**NEXTERA ENERGY POINT BEACH, LLC
POINT BEACH NUCLEAR PLANT, UNITS 1 AND 2**

**LICENSE AMENDMENT REQUEST 261
EXTENDED POWER UPRATE**

NON-PROPRIETARY RESPONSE TO REQUEST FOR ADDITIONAL INFORMATION

December, 2009

Figure 17a: Core Mixture Level

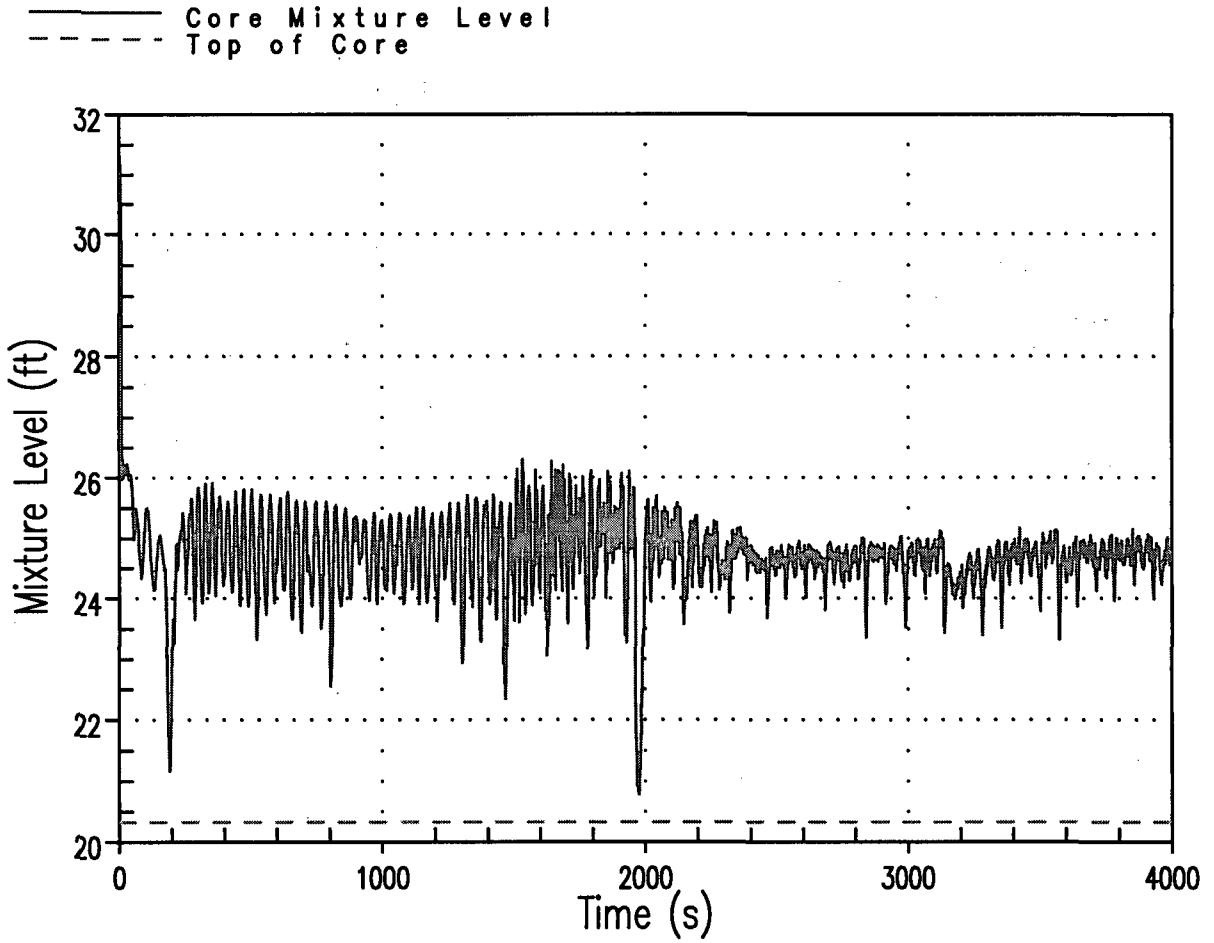
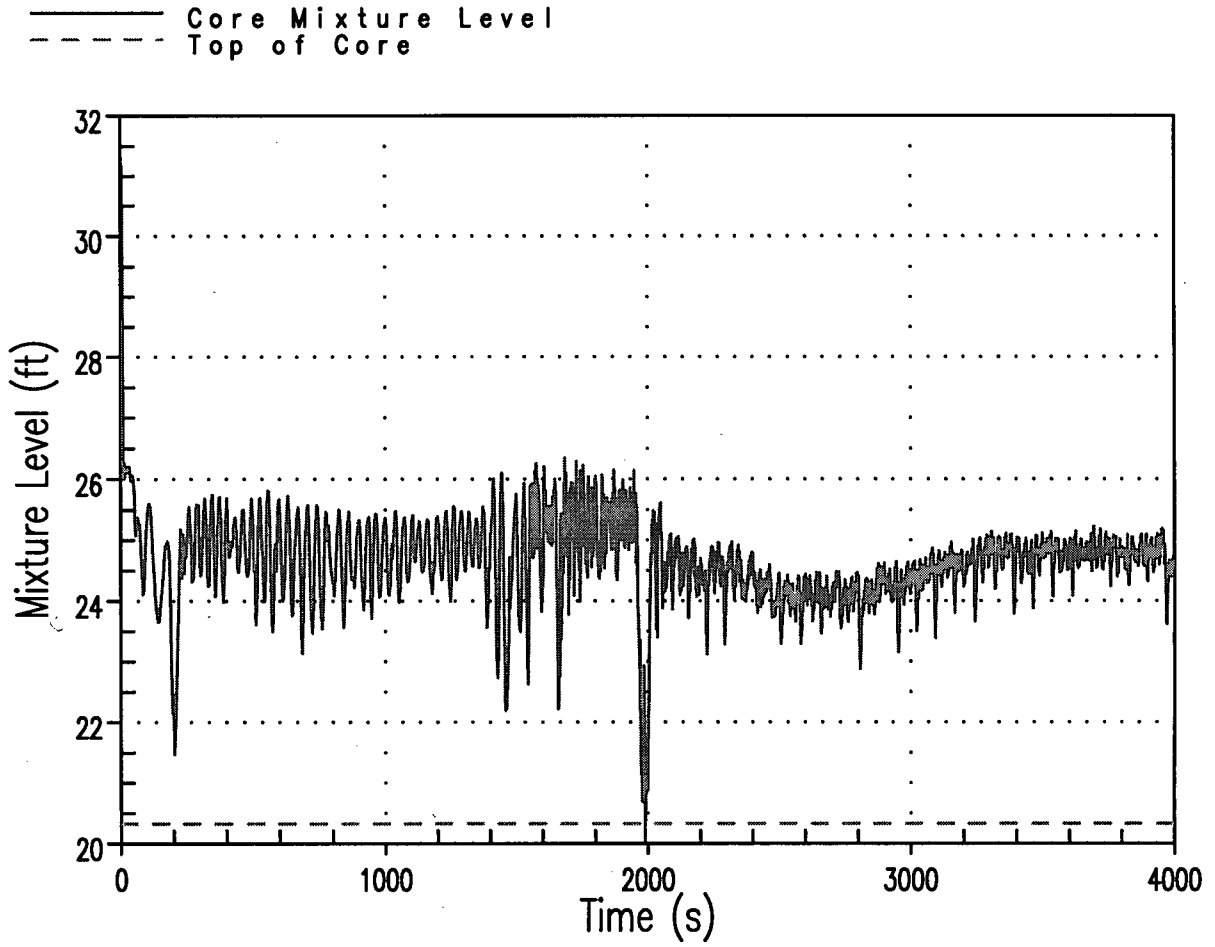
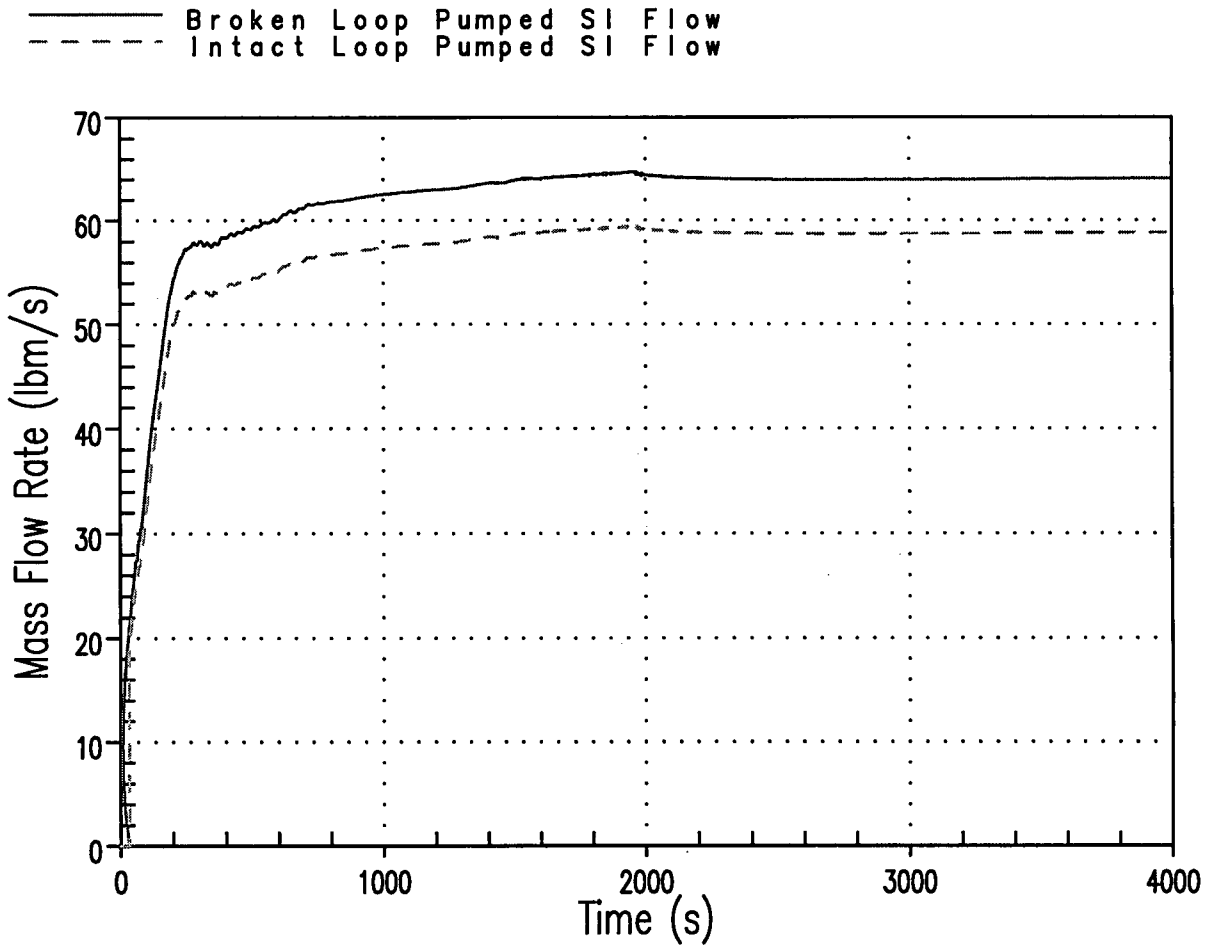
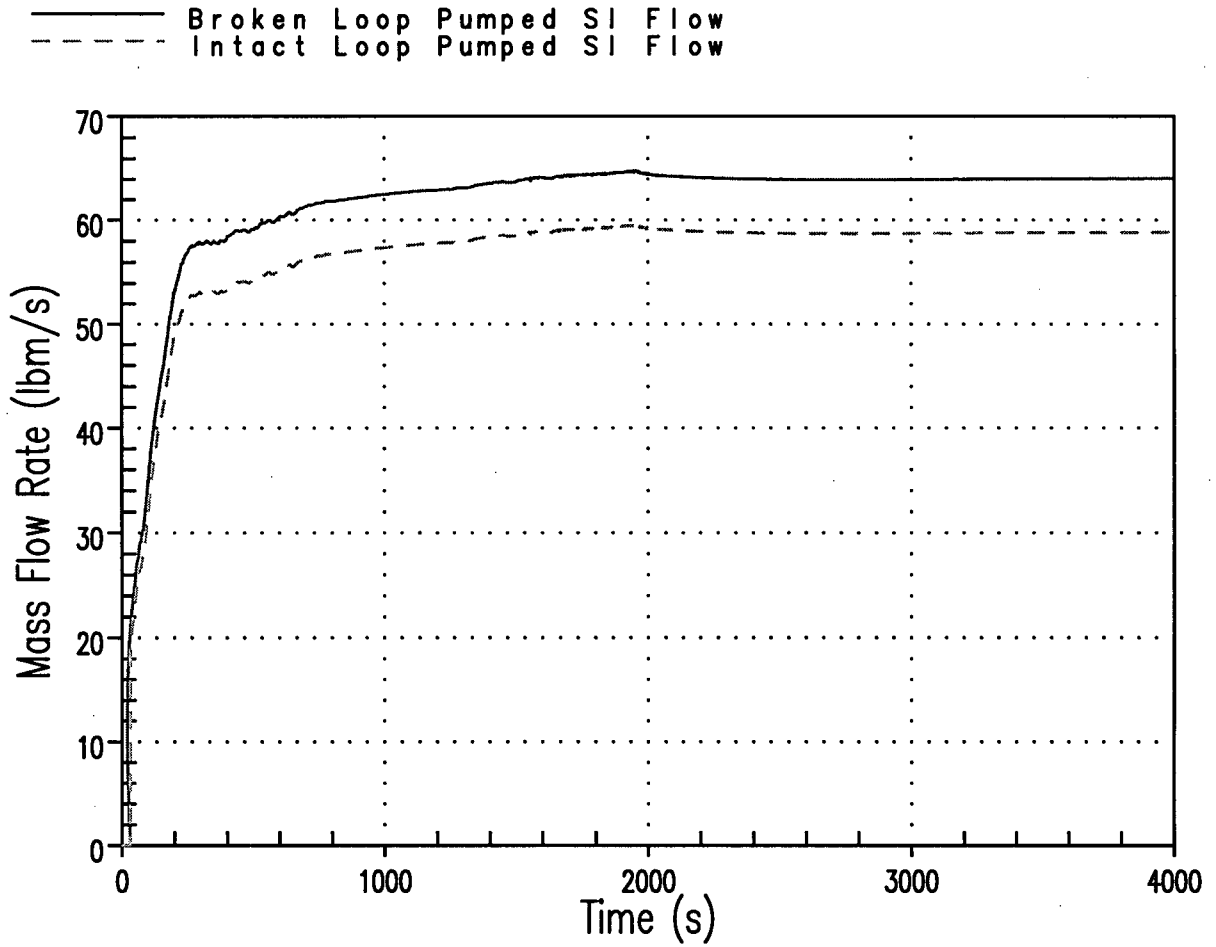
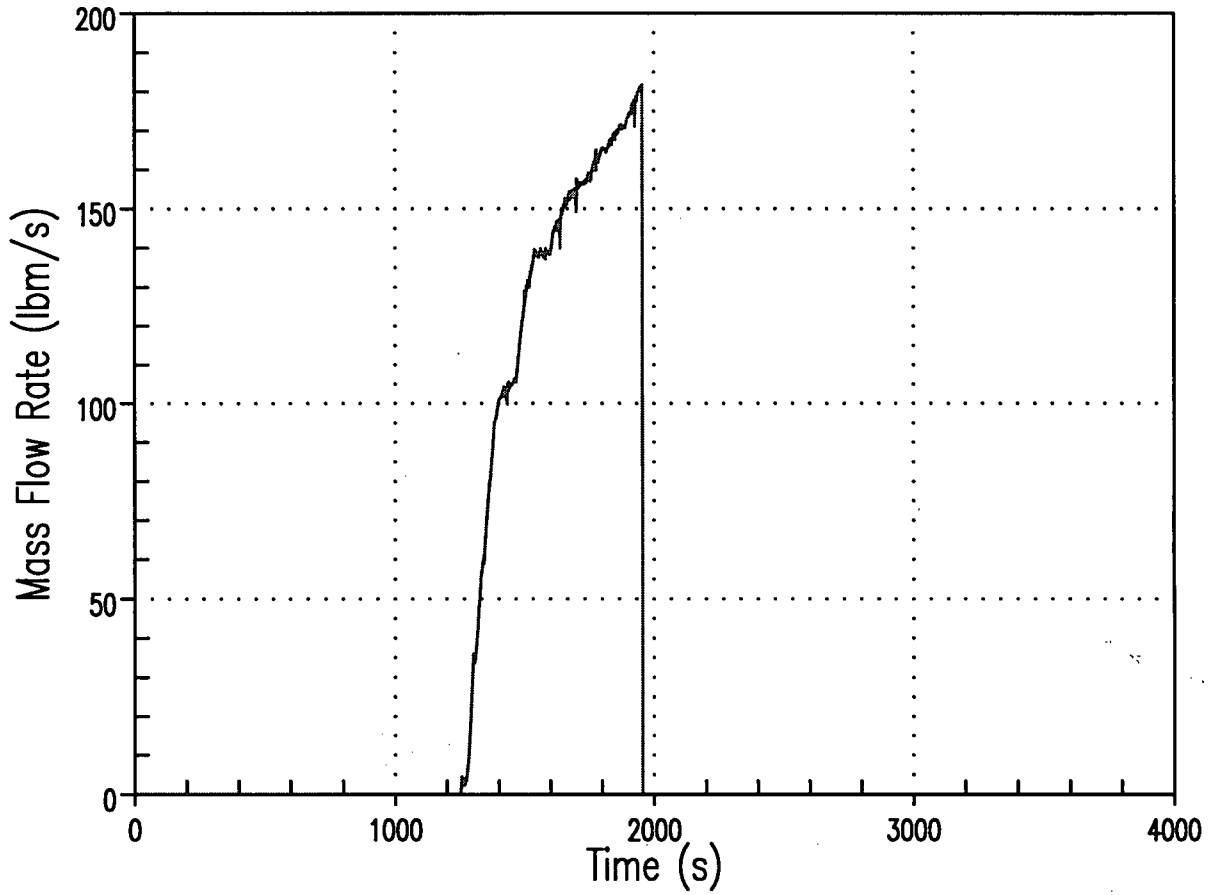
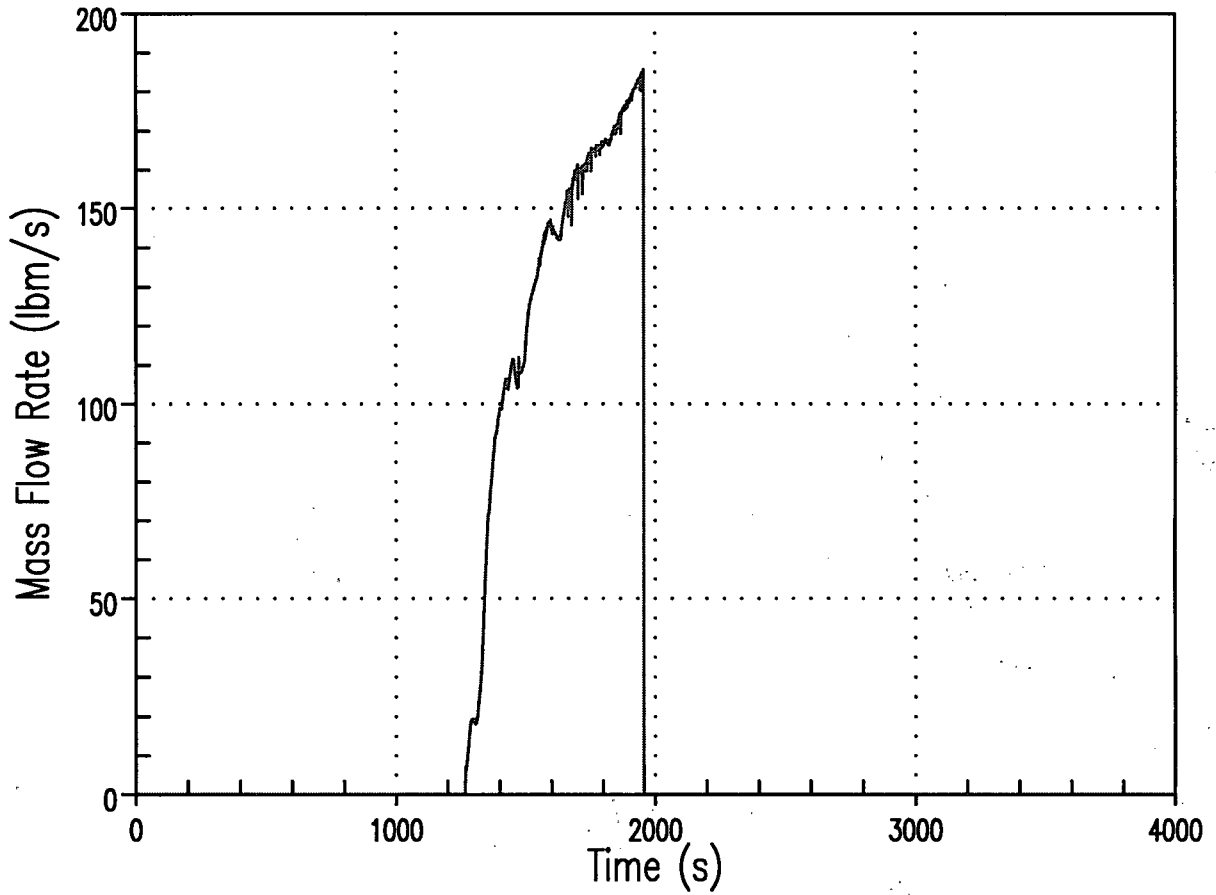
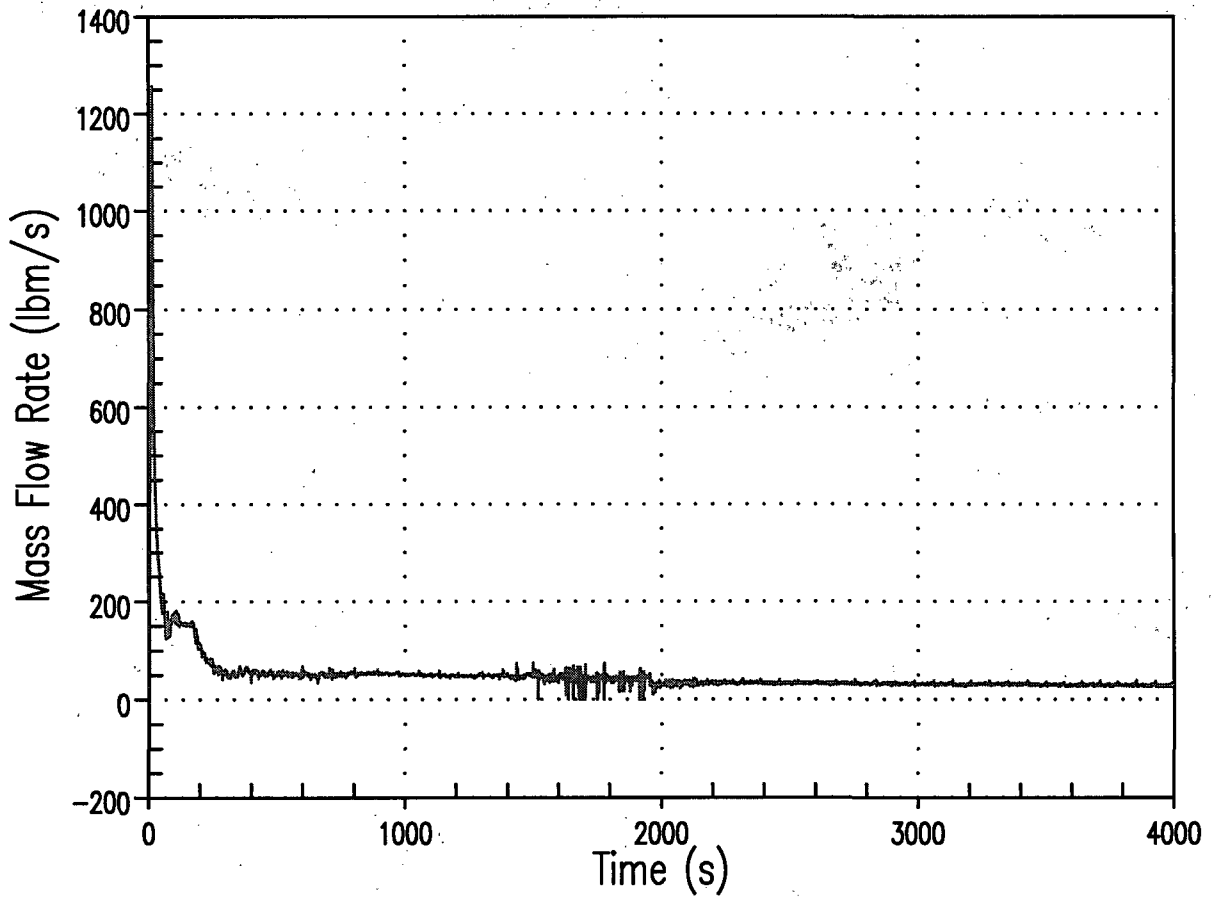
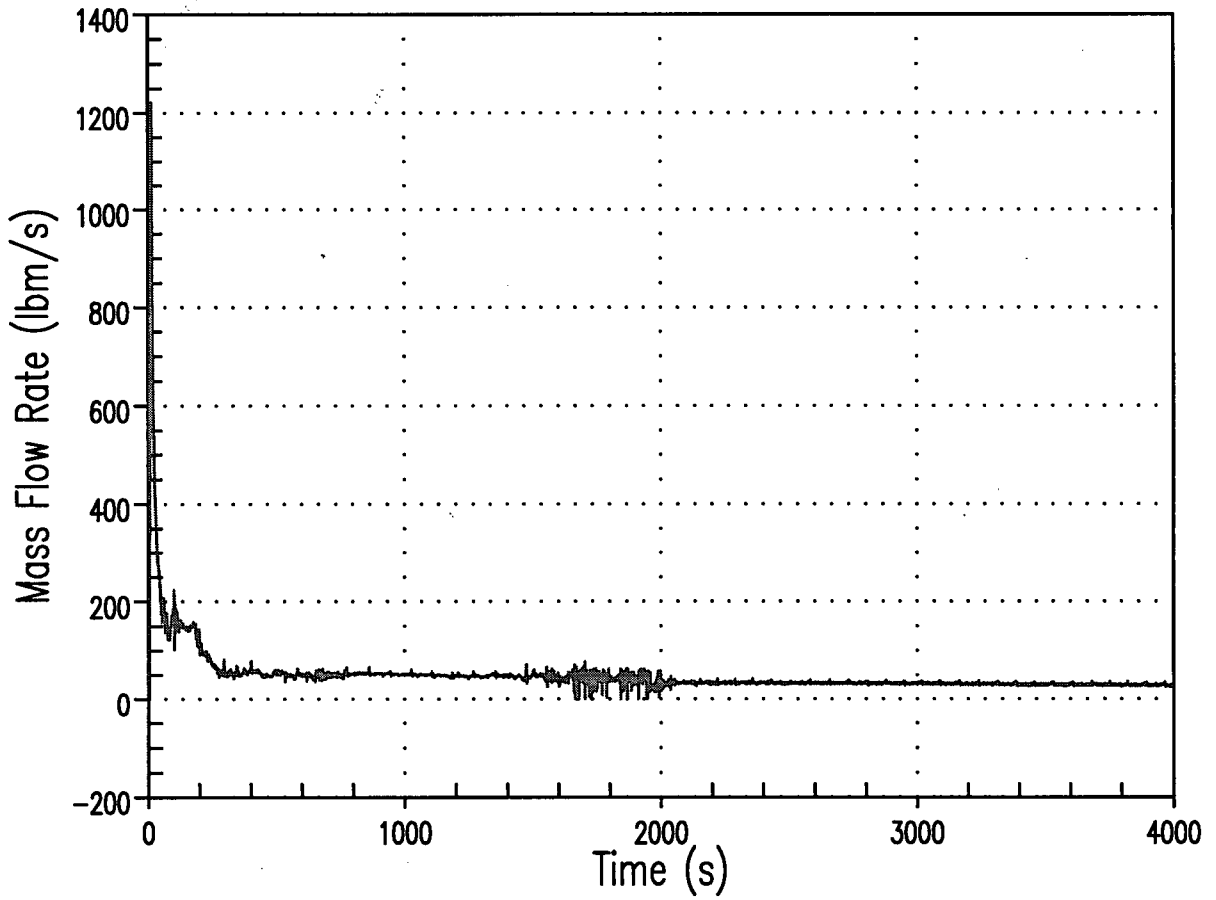
- 1) Page 2.8.5.6.3-6 of the Point Beach Extended Power Uprate (EPU) Licensing Report (Enclosure 5 to Reference 1) indicates that the small-break loss-of-coolant accident analysis was performed using the NOTRUMP evaluation model. Please provide a copy of the NOTRUMP analysis report that supports the EPU application.**

The NRC reviewer provided clarification of this RAI during a teleconference held between Westinghouse, FP&L, and the NRC. It was concluded that the transient response results of the non-limiting breaks, which are not provided in the LAR, will be provided. Transient response results for the limiting 3-inch break for both Point Beach Units 1 and 2 are provided in the small break LOCA LAR Section 2.8.5.6.3. The same response results for the non-limiting breaks are provided below. The following comments apply:

- Peak cladding temperature transients are not provided for the 6- and 8.75-inch breaks as these breaks experienced little to no core uncover.
- Low head safety injection flow figures are provided only for the 6- and 8.75-inch breaks. LHSI was only modeled for the 6- and 8.75-inch breaks (during RWST injection phase only). Breaks less than 6-inches in equivalent diameter did not reach the LHSI cut-in pressure.
